D/DRC Case

3230 Devereaux Road

DESIGN/DEVELOPMENT REVIEW COMMISSION
DESIGN REVIEW DISTRICT
HISTORIC AGENDA
EVALUATION SHEET
Case # 9

NATURE OF REQUEST: Request Certificate of Design Approval for addition and exterior changes

Right elevation showing new rear addition and porch enclosure, submitted by applicant. Red arrow indicates blank wall that would likely need an additional opening to meet the guidelines.

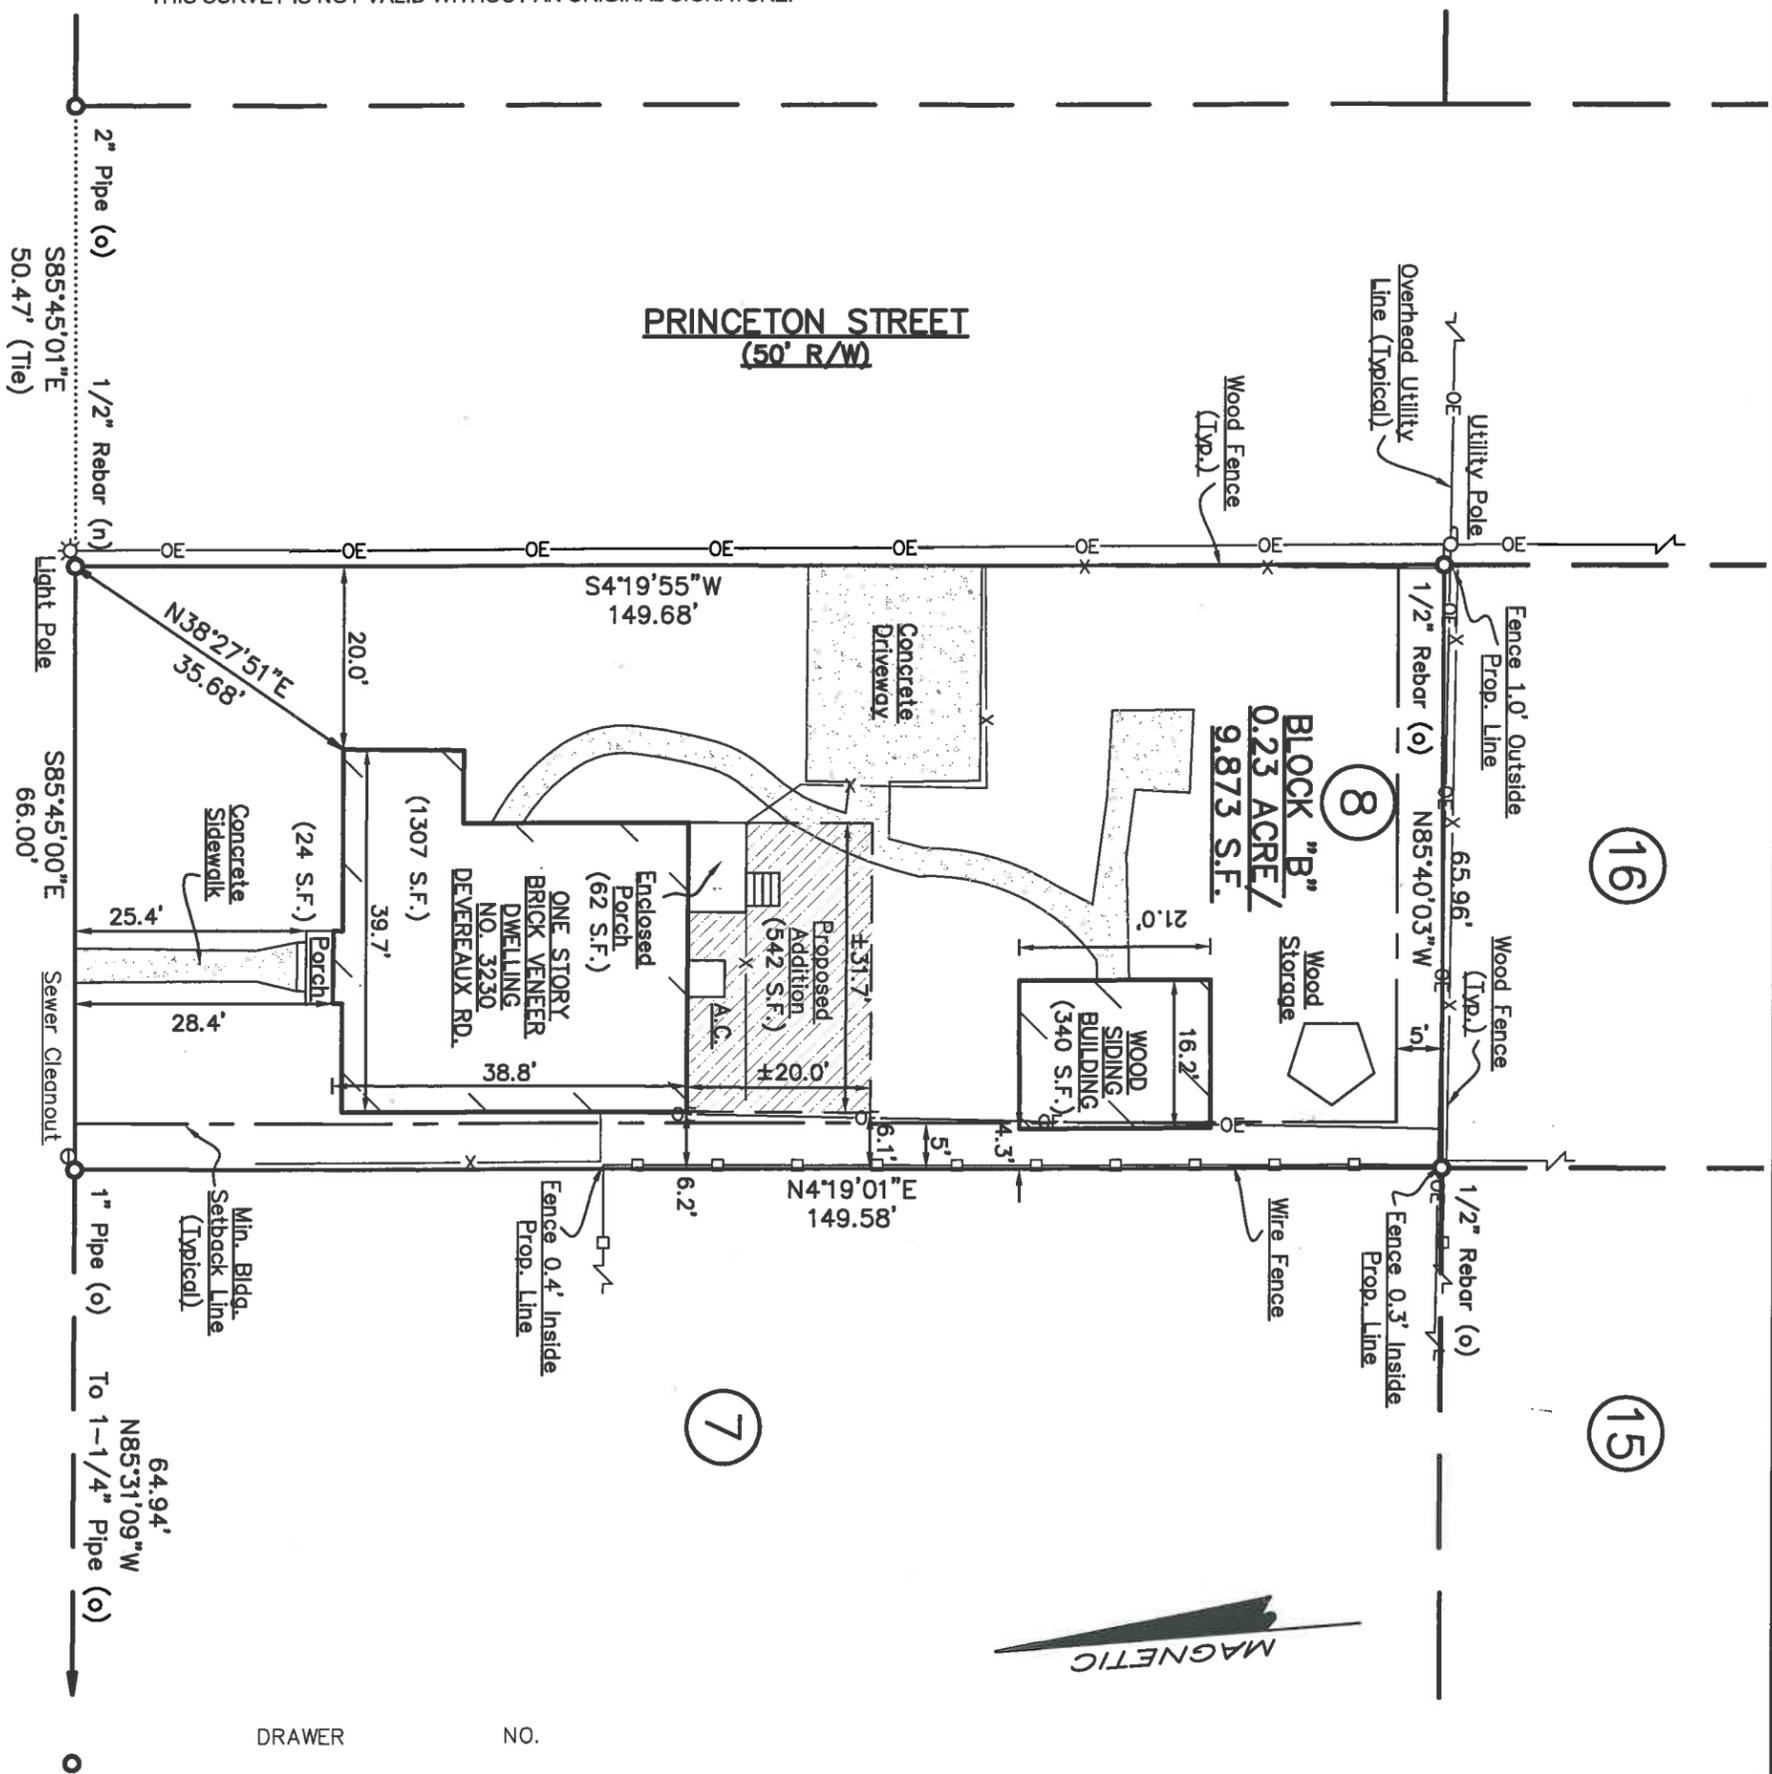
The massing is somewhat compatible with the building but there is a large expanse of wall that is unlike the house on the east side of the addition. This is the side facing Princeton Street and it is very visible. An additional opening along this elevation would allow the massing to meet this guideline. If the interior floor plan does not accommodate a window, then the wall could be finished out on the interior of the window so that the exterior still shows the proper massing.

On the new rear wall of the addition, the proposed new construction has a rhythm of openings that is compatible with the historic house and with other historic buildings nearby. On the wall facing Princeton Street (east wall) the rhythm is not compatible in the new wall, as there is only a single opening in a 20-foot wall. The established pattern on the historic east wall has grouped openings in a fairly regular rhythm. An additional opening toward the back wall on the new east will would be a recommendation for meeting this guideline.

- That the eaves of the addition use wood or cement fiberboard rather than vinyl
- That the addition receive an additional window opening in the east wall
- That the porch enclosure gain additional glazing in the front and rear wall to match the pattern of the east wall and maximize the transparency of the enclosure and remove any proposed walls
- All details be deferred to staff

FRONT ELEVATION $\frac{1}{8}'' = 1'-0''$

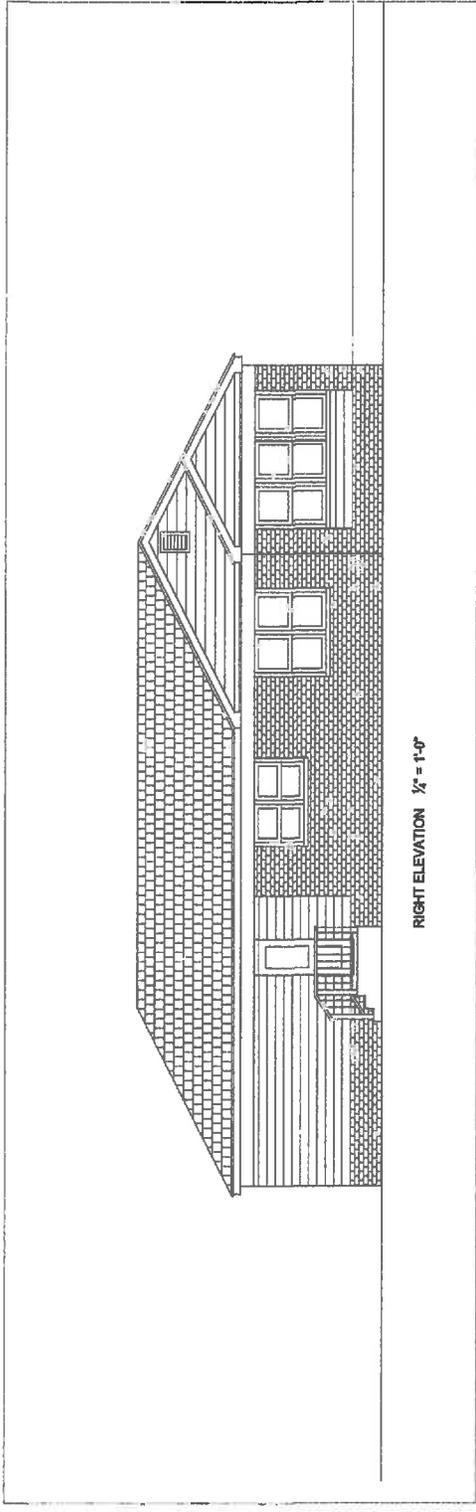
The front and back walls of the porch enclosure do not appear to meet this guideline as they introduce a generous amount of solid wall with only a centrally located single window. The additional solid walls in these areas do not appear to maintain the openness of the porch as they use a minimal amount of transparent materials.

Proposed front elevation, submitted by applicant; note the large volume of wall space surrounding the single window

To meet this guideline both the front and back wall of the side porch, which is visible due to its location on a street corner, should follow the pattern set on the side wall of the proposed enclosure and use grouped windows to maximize the transparency of the walls.

RIGHT ELEVATION $\frac{1}{8}'' = 1'-0''$

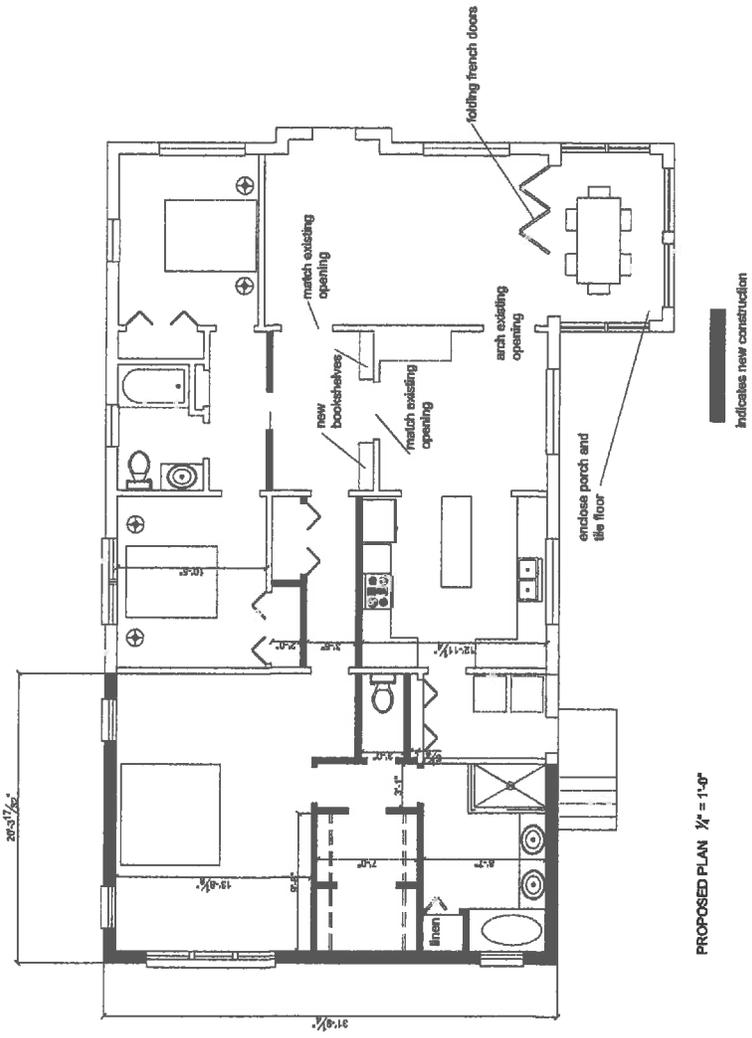
The porch enclosure appears to meet this guideline on its east wall, which has three windows filling up the opening between the two brick columns over a short base of solid wall clad in cement-fiberboard siding.
